ADDENDUM NO. 2 TO PROJECT NO. Q2020

CONSTRUCTION, HVAC, AND ELECTRICAL WORK REPLACE ROOF, MESS HALL, BUILDING 5 FIVE POINTS CORRECTIONAL FACILITY 6600 STATE ROUTE 96 ROMULUS, NY

March 12, 2026

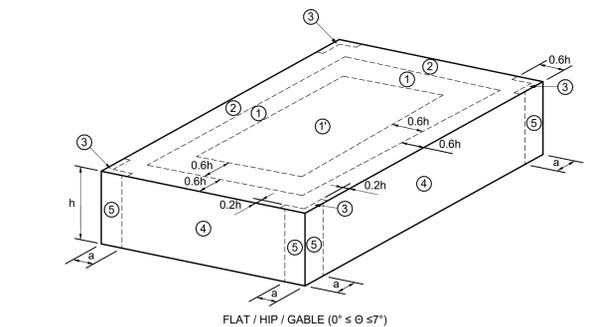
4. Revised Drawing:
 - a. Drawing No. G-002, noted Struct. Design Data dated 2/27/2026, accompanies this Addendum and supersedes the same numbered previously issued drawing.
